**DEPARTMENT OF TRANSPORTATION
STATE OF GEORGIA**

FILE: I-95 @ SR 21 DDI, Chatham County **OFFICE:** Innovative Delivery
PI No.0012722
Design-Build **DATE:** October 1, 2014

SUBJECT: Request for Design Exception

Subject:
Request for Design Exception – Horizontal Alignment
P.I. No. 0012722
Chatham County
SR 21 at I-95 Diverging Diamond Interchange

Project Layout

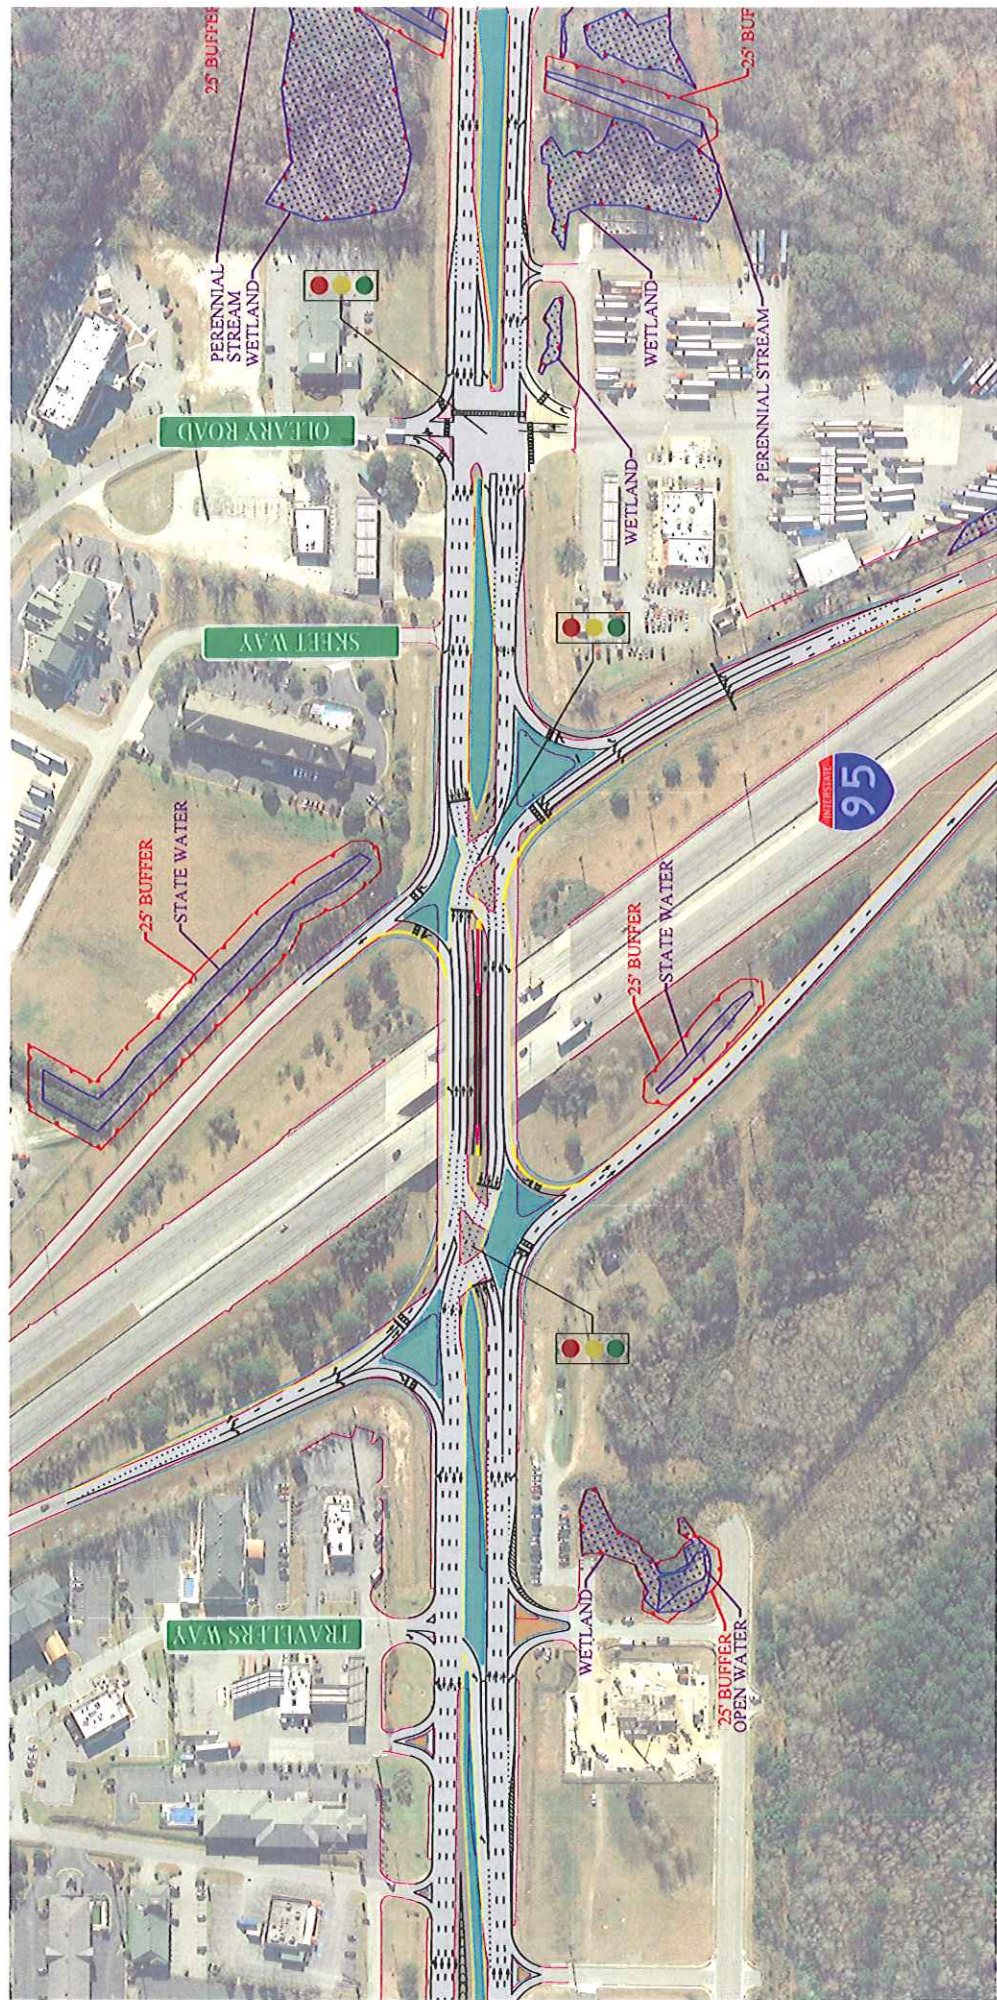
Design Exception Request: to use radius less than the 35 mph Design Speed for the crossovers inside the diverging diamond interchange.

At locations where the "cross over" of traffic occurs just north and south of the SR 21 underpass, the project will match existing cross slopes. The existing typical section in these areas is a normal crown section. Therefore, exhibit 3-16 of AASHTO requires a 510 ft turning radius for 35 mph turning movements with normal crown (*Attachment 3*).

Due to the inherent design of a diverging diamond interchange and the limited amount of available right of way, we propose 300 ft as the minimum turning radius at these cross over locations. The AASHTO criteria is a 510 ft radius. If the project were to be required to meet the standard, the intersection crossing angle would need to be smaller than desirable. There is no Right of Way on this project. There will be no additional construction cost of using a 300 ft radius as opposed to a 510 ft radius.

The project will be clearly striped, with additional signing and marking beyond what is required to enhance clarity and safety for users. Additionally, the functionality of this interchange by the nature of the crossovers that require the design exception eliminates the most severe type of crash, which are angle collisions. The design

Based on these criteria and circumstances, the design team recommends approval of the design exception.
